**November 15, 2018**  
**BOARD OF COUNTY COMMISSIONERS**  
**ORANGE COUNTY, FLORIDA**  
**Addendum No. 1, IFB Y19-711-RC**  
**PARKS CAMP JOY SEWER & SANITARY FORCE MAIN**

# Addendum No. 1, IFB Y19-711-RC PARKS CAMP JOY SEWER & SANITARY FORCE MAIN

## STANDARD ROADWAY OPENCUT CROSS SECTION DETAIL

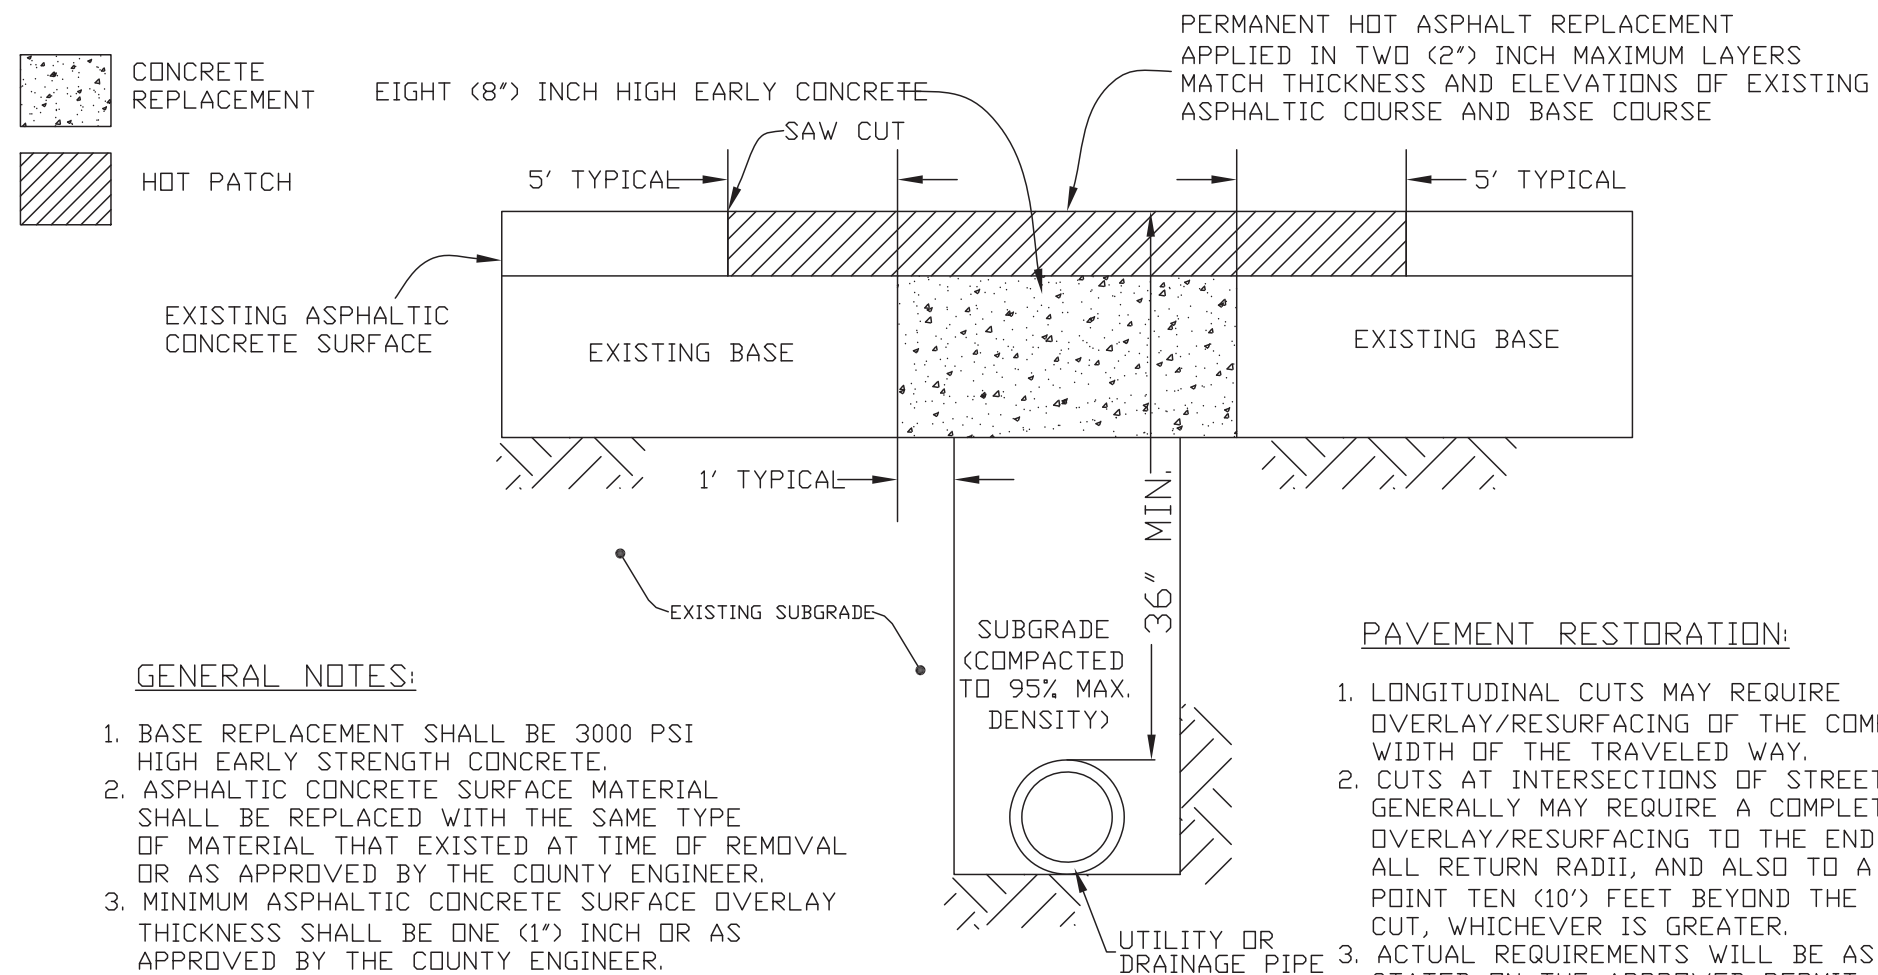
1. **Addition:** Permitting comments from Orange County Development Engineering require use of Orange County's Standard Open Cut Detail. Please see attached, noted as "ATTACHMENT 1,

SUB-GRADE CUT TO BE COMPACTED TO 95% MAX. DENSITY AS DETERMINED BY AASHTO T - 180.  
CUT TO BE REPLACED WITH AN EIGHT (8") INCH 3000 PSI HIGH EARLY CONCRETE TO TOP OF EXISTING BASE.  
CUT AREA TO BE PLATED OR PROTECTED ON DAY OF POUR. EXISTING SURFACE TO BE SAW CUT  
TO AN AREA FIVE (5') FEET, BEYOND THE BASE CUT.
